Virgil C. Summer Nuclear Station (VCSNS) Units 2&3
Combined License Nos. NPF-93 and NPF-94
Docket Nos. 52-027 & 52-028

Subject: LAR 17-01: VCSNS Units 2&3 Request for License Amendment:
Classification of Nonsafety-Related Instrumentation

Enclosure 1: Request for License Amendment: Classification of Nonsafety-Related Instrumentation (LAR 17-01)

Figure 1: Safety Classification of Instrumentation Sensing Line, Manifold, and Instrument

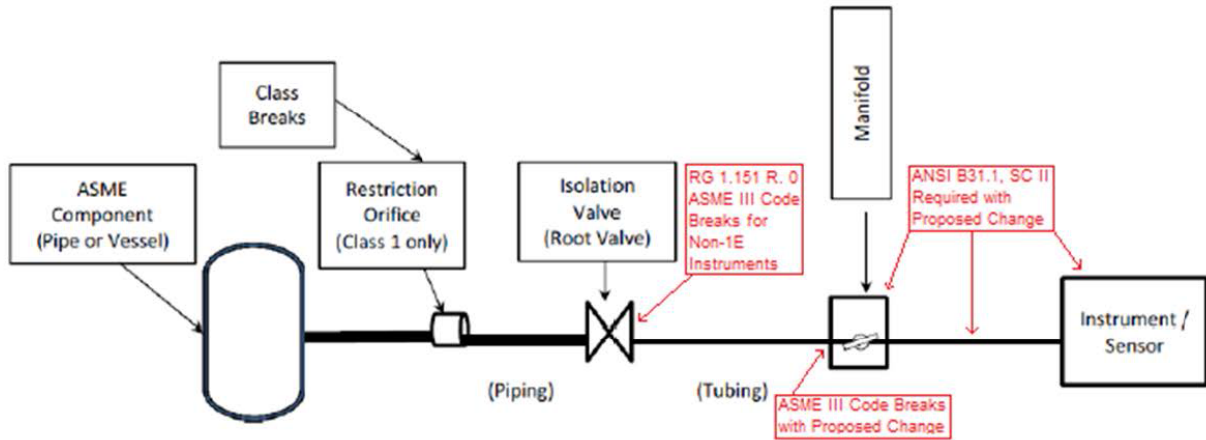
In the absence of specific UFSAR requirements, this amendment request proposes adding a new classification methodology to UFSAR Subsection 3.2.2.8 applicable to the instruments listed in Table 1. Specifically, the proposed activity adds information to UFSAR Subsection 3.2.2.8 to describe that the instrument, manifold, and impulse line of nonsafety-related instruments that monitor safety-related pressure boundaries be classified as equipment Class D, seismic Category II. The instrument sensing line from the system piping to the manifold, including the instrument isolation valve, are proposed to be safety-related, seismic Category I. The equipment class applied to the safety-related portions is proposed to be the same as that of the monitored system, which is the same approach applied to safety-related instruments. The proposed changes are shown in the highlighted portion of Figure 1 below.

Note: Section in red border reflects proposed changes, other sections are consistent with current classification methodology.

The proposed change in AP1000 classification methodology for non-1E instruments connected to safety-related systems would transition the sensing lines from safety-related, seismic Category I to nonsafety-related, seismic Category II at the inboard connection to the instrument manifold. This added conservatism exceeds the requirements of Regulatory Guide 1.151, Rev. 0 and ISA S67.02-1980 as neither require extension of ASME Section III beyond the accessible isolation valve for non-1E instrumentation. Beyond this connection, where neither Regulatory Guide 1.151, Rev. 0 nor ISA S67.02-1980 require seismic Category I, the proposed change requires AP1000 equipment Class D, seismic Category II. Additionally, the manifold, instrument, and impulse line are all mounted on the same seismic Category I mounting plate.

| Plant-Specific Change | Description of Proposed Change |
|-----------------------|---|
| UFSAR Section 3.2.2.8 | Revise to state that for nonsafety-related instruments interfacing with safety-related pressure boundaries, the instrument sensing lines and isolation valves have safety-related pressure boundary function, and the instrument manifold, sensor and impulse line are nonsafety-related and seismic Category II. |
